Modernization of sump filters design on ROVNO NPP

Y. Armand*
J.M. Mattéi*
A. Gorbachev*
A. Mekhed**
V. Redko***

ABSTRACT: Taking into account the major importance to solve sump plugging in case of primary break, modernization of sump filters design on ROVNO NPP has been engaged. This action has been realized using a «2+2» approach, which had been proposed by the Commission of the European Community (CEC) in 1998, with the purpose of effectiveness increase of activities under realization of TACIS program projects. This paper gives a short summary of the different actions performed by the Technical Support Organization (IRSN, France), the State Scientific and Technical Center for Nuclear and Radiation Safety (SSTC NRS, Ukraine), the State Nuclear Regulatory Committee of Ukraine (SNRCU), the ROVNO NPP, assisted by EDF and the designer (FORTUM and FRAMATOME).

Tested section of the filter system

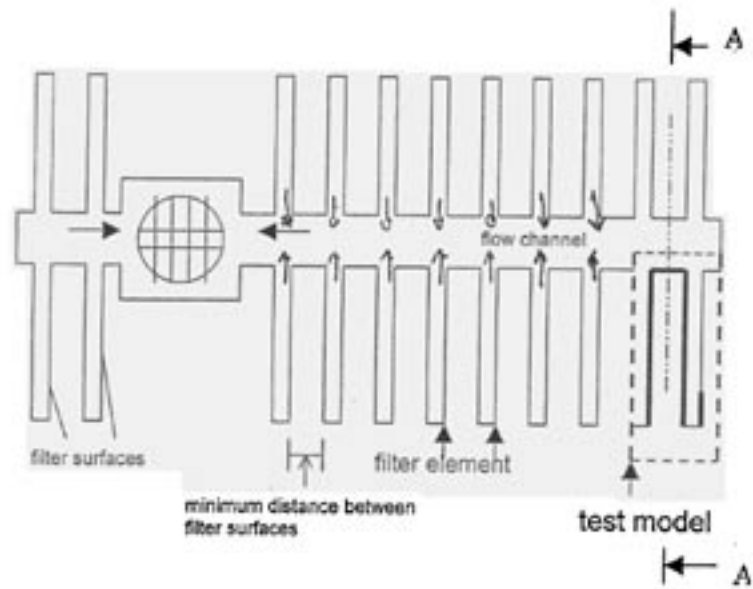
- taking into account the fact that the Containment Spray System is in operation during a LOCA and consequently able to washdown all, or a part, of thermal insulation located on the loops, the amount of thermal insulation dislodged could be strongly higher than when it is just considered a steam/water jet effects and the design of new filters. A review was required,

- a spherical model was used to estimate the amount of thermal insulation destroyed. A ratio of 7 was proposed by the designer which led to an amount of 200 kg to be considered to design the filters. The L/D ratio to be considered is full of uncertainties and the value can vary from 10 (US studies) to 40 (VATTENFALL and SKI estimation). Also, a second approach considering a ratio of 12 was proposed and a mass of about 800 kg was reviewed. Moreover, the transported fraction was discussed,

- consideration about the maximal values of the flow rates of ECCS and CSS was required,
 - consideration on the efficiency of the new sump (filtering area, distance between filtering surfaces) was required,

- consideration on the test program was required. It concerned:
 - the calculations and justifications of the maximal velocity including those at the junction between flow channel and filtering element,

According to experts' recommendations, designer of filters carried out additional model tests under temperature 80° C and duration 96 hours in comparison with the 24 hours recommended in the RG 1.82. Changes concerning assurance of required flow rate under operation of filters had been introduced into design.

Filter element principle

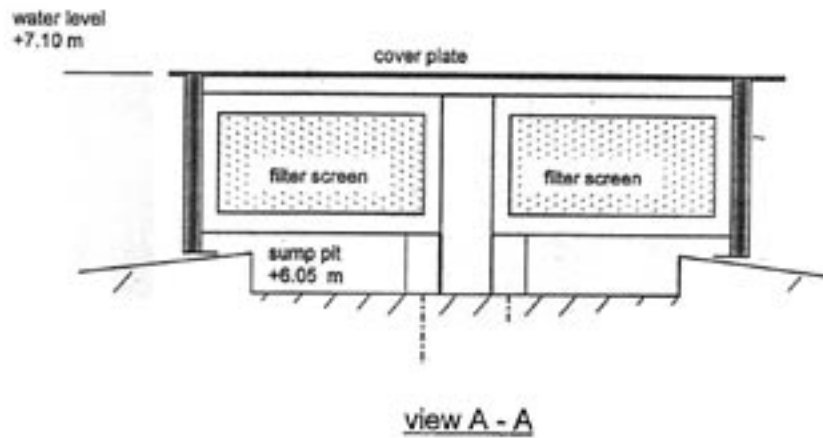
- consideration about mechanical behavior of the screens under maximal head loss was required. The designer proposed to justify it in the detailed design,
